Urgent Field Safety Notice

Medtronic StrataMR™ Adjustable Valves & Shunts

Model numbers 42955, 42965, 45905, 46955, 46960, 46965, and 46970
Recall

Medtronic reference: FA759

Figure 1
Example of a **Correct** rotor
orientation

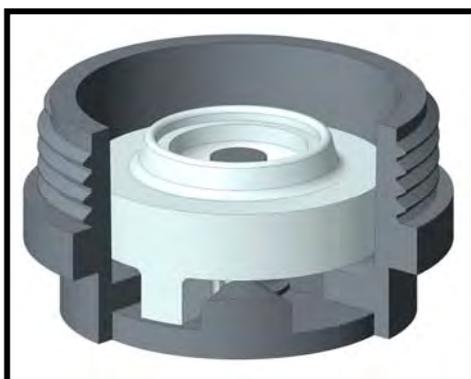
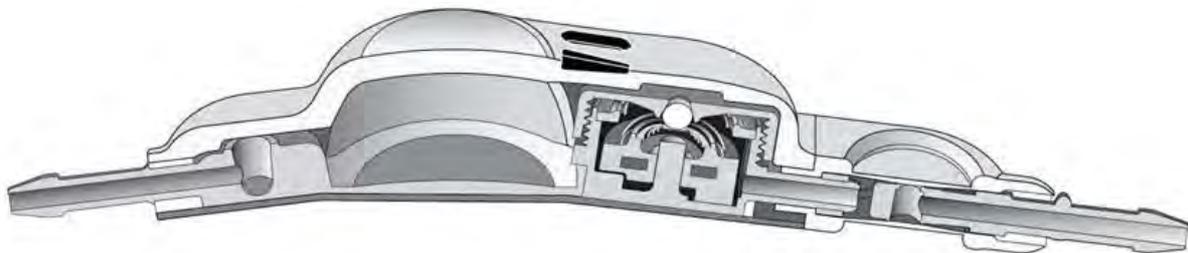
You are receiving this letter because you may have received one or more of the affected products. Medtronic is initiating this voluntary recall because the products identified above may experience a condition that may, in limited circumstances, affect the flow resistance in the valve and result in underdrainage of cerebrospinal fluid (CSF). The condition can occur when the valve mechanism is adjusted to a position that causes a higher than intended flow resistance. This higher than intended flow resistance is a result of the MRI Resistance Key on the bottom of the valve's rotor mechanism being placed on top of one of the MRI Resistance Walls, instead of in one of the pressure setting wells (see **Figures 1 & 2**). This condition only occurs during the valve adjustment process.

Figure 2
Example of an **Incorrect** rotor
orientation

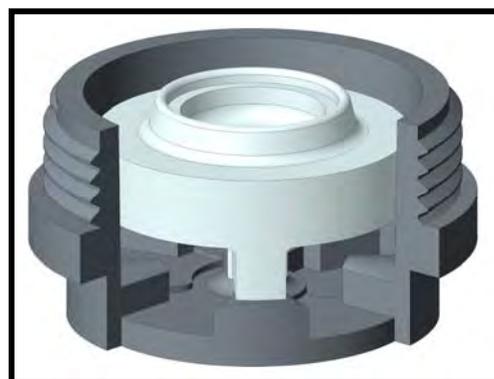
When the StrataMR™ valve is set in an orientation as seen in Figure 2, pressure flow performance approximately twice the level above StrataMR's highest Performance Level setting of 2.5 can occur and lead to cerebrospinal fluid (CSF) underdrainage. This condition may result in the following adverse health consequences: headaches, nausea, vomiting and lethargy. If left untreated underdrainage has the potential to lead to coma and death.

The incorrect valve rotor orientation (Figure 2) can be caused by misalignment and/or off-center positioning of the StrataMR™ Locator Tool, relative to the valve mechanism.

Figure 3
Correct
Good Alignment and Centering
of Locator Tool and Valve Mechanism

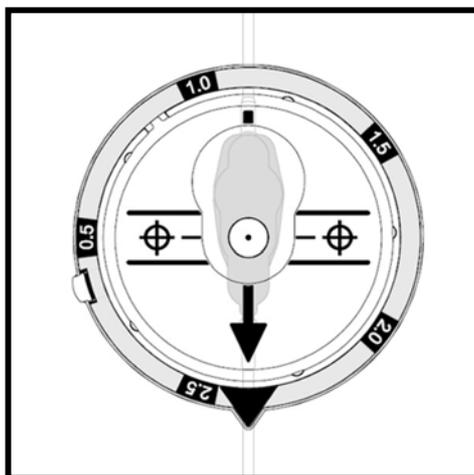
Figure 3 provides an example of proper/correct technique. Figures 4, 5, & 6 provide examples of incorrect alignment and centering techniques that should be avoided.

As part of the adjustment process of the StrataMR Adjustable Valve system, it is important to note that if the valve's pressure flow setting is accurately aligned and centered via proper technique as described in the IFU (also see Figure 3 and the instructions in Addendum A), the valve MRI Resistance Key will be set to the correct pressure setting well.
